ALLAMAKEE CSD MIDDLE SCHOOL HVAC UPGRADE
WAUKON, IOWA

ADDENDUM 02
March 6, 2026

MAU-2 & MAU-3 INTERCONNECTION DETAIL 1
NTS E-504

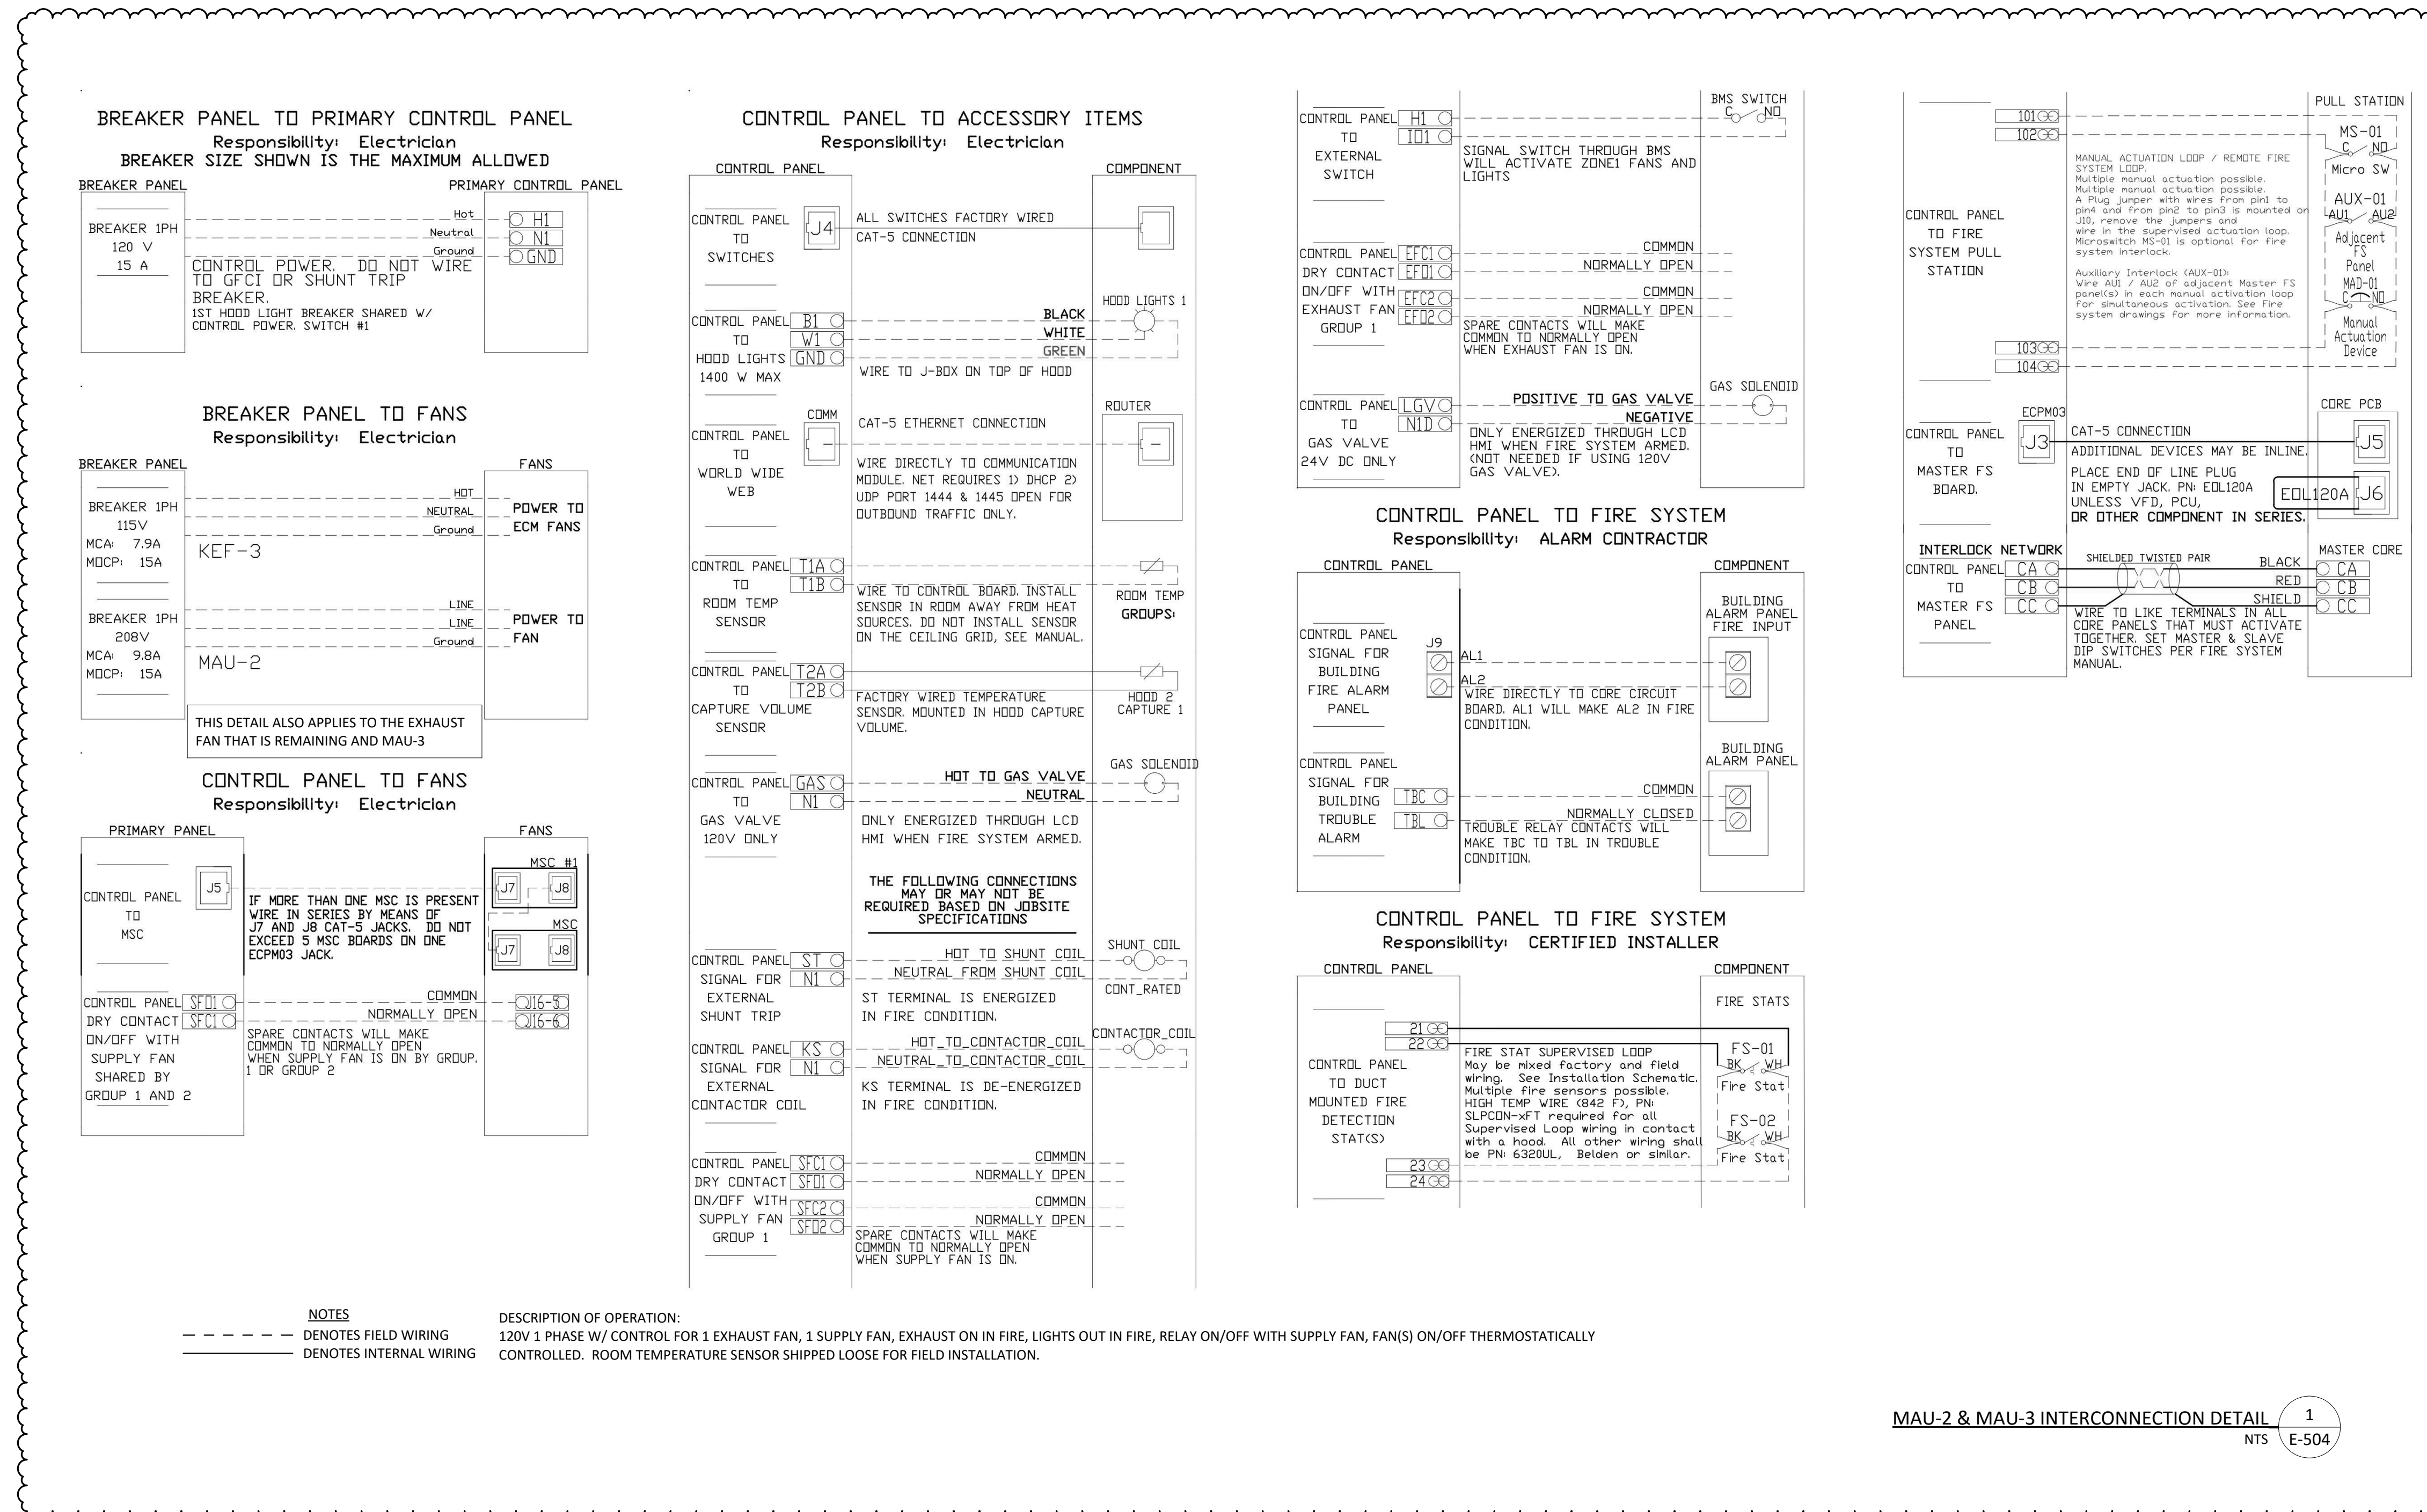
- E2-7 Drawing **E-503 – ELECTRICAL DETAILS**
 1. Revised details for kitchen HVAC equipment.
- E2-8 Drawing **E-504 – ELECTRICAL DETAILS**
 1. Revised details for kitchen HVAC equipment.
